Access Compliance Report

Public Rights-of-Way

(Curb Ramps)

Intersection ID: 15657	Main Street: CUMBERLAND_AV	Cross Street: LYNWAY_DR	Location: W
ADA ID: 3FB21E578F84	Ramp Type: PerpDiag	Initial Pass/Fail: Fail	Overall Compliance: No
Codes/Mitigation Info/Possible Solution		Field Measurements/Component Compliance

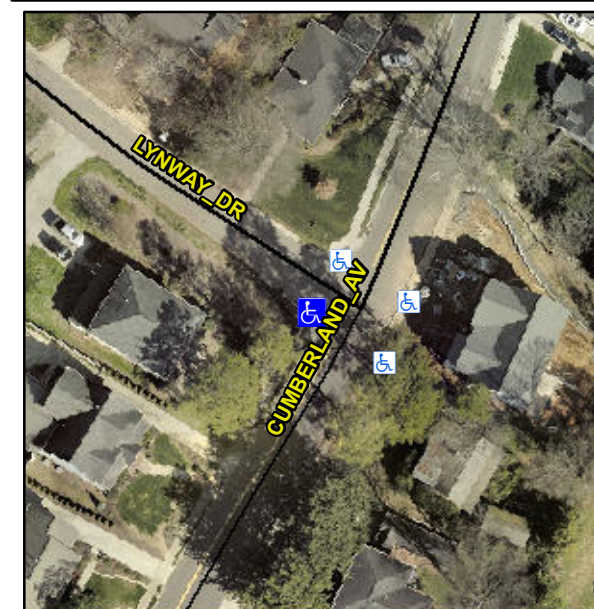
Not Found, R304.2.2, R304.5.3

Compliance	Description	Data	Compliance	Description	Data
N/A	Ramp Length (in)	68.0	No	Ramp Slope (%)	11.7
Yes	Ramp Width (in)	48.0	No	Ramp XSlope (%)	4.0
N/A	Flare Type LT	N/A	N/A	Flare Type RT	N/A
N/A	Flare Slope LT (%)	N/A	N/A	Flare Slope RT (%)	N/A
N/A	Flare Traversable LT?	N/A	N/A	Flare Traversable RT?	N/A
N/A	Landing Length (in)	N/A	N/A	DWS Provided?	N/A
N/A	Landing Width (in)	N/A	N/A	DWS Contrast?	N/A
N/A	Landing Slope (%)	N/A	N/A	DWS Length (in)	N/A
N/A	Landing X Slope (%)	N/A	N/A	DWS Full Width?	N/A
N/A	Landing Curb? (Y/N)	N/A	N/A	DWS Offset (in)	N/A
N/A	Shared Landing?	N/A			
N/A	Gutter Ponding?	N/A	N/A	Gutter Slope (%)	N/A
N/A	Gutter Lip Ht (in)	N/A	N/A	Gutter X Slope (%)	N/A
N/A	Painted X Walk1?	No	N/A	Painted X Walk2?	No
	X Walk 1 Direction	To SE		X Walk 2 Direction	To NE
N/A	X Walk 1 Width (in)	N/A	N/A	X Walk 2 Width (in)	N/A
	X Walk 1 Slope (%)	2.7		X Walk 2 Slope (%)	1.9
	X Walk 1 X Slope (%)	4.3		X Walk 2 X Slope (%)	2.4

Remove & Replace Curb Ramp With Two New Directional Ramps or Equivalent.
